BEFORE THE PUBLIC SERVICE COMMISSION OF UTAH

In the Matter of the Application of
PacifiCorp’s 2013 Integrated Resource Plan

DOCKET NO. 13-2035-01

Initial Comments of Utah Clean Energy

Figure 2.6 Average Installed Price by Market Segment, Q1 2011 – Q1 2013

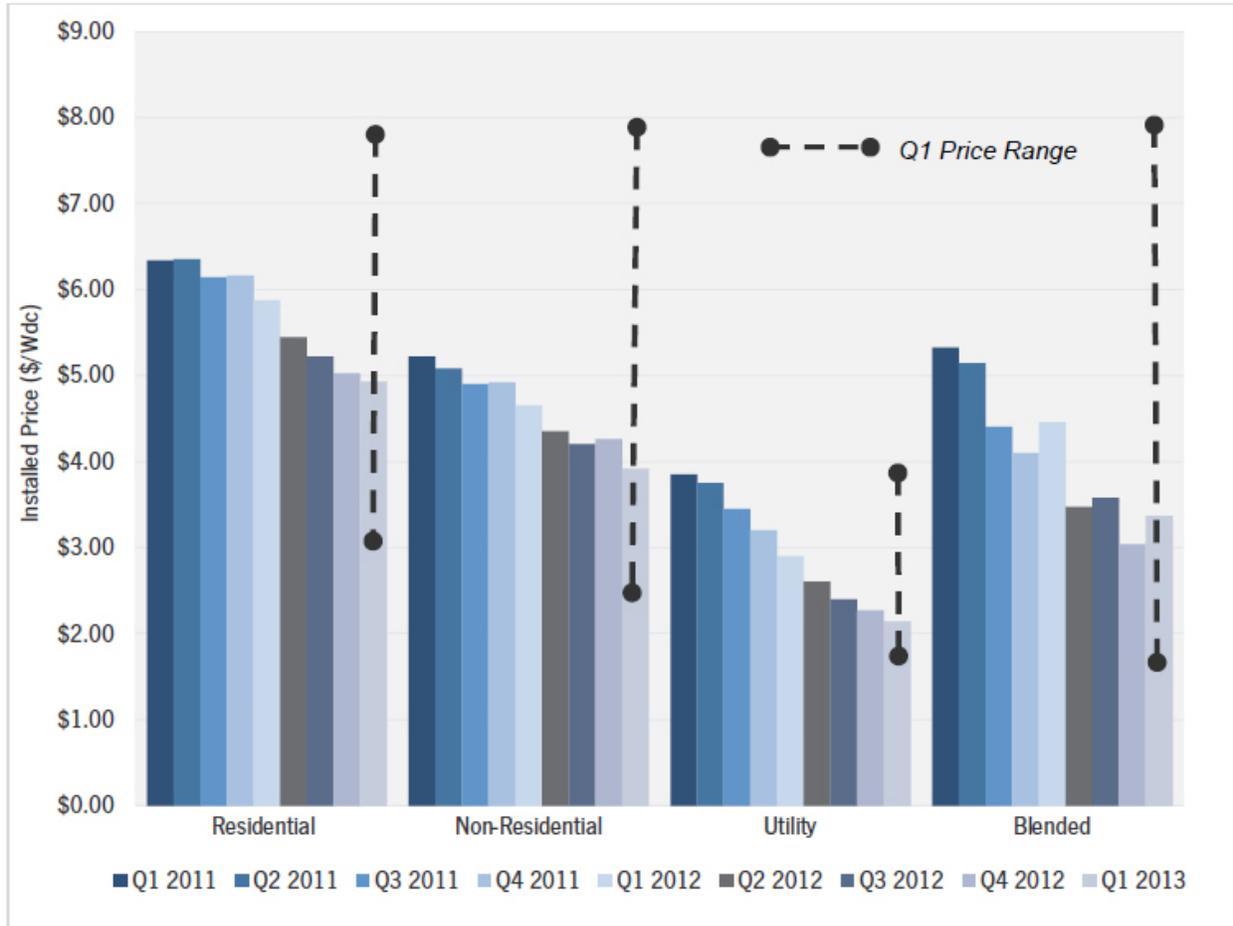
Lastly, as we have pointed out in previous comments, the solar PV costs used in the 2013 Cadmus Analysis and the IRP are too high and too outdated to accurately represent the current solar market prices, which are vastly different from 2011 prices. According to the Solar Energy Industries Association, the average cost of a completed PV system dropped by 24 percent over

the past year [from Q1 2012 to Q1 2013] to \$3.37/Watt across all sectors, and the average price of a solar panel has declined by 60 percent since the beginning of 2011 (see figure 2.6).³¹

- 1) We recommend that the Company re-analyze the market potential for distributed solar, given today’s solar costs and installation trends.
- 2) Update the distributed solar PV costs to reflect current costs and projected cost trends.
- 3) Use the updated solar PV market potential and solar PV costs in the IRP Update Analysis.
- 4).Update the solar PV market potential and solar PV costs prior to the 2015 IRP.
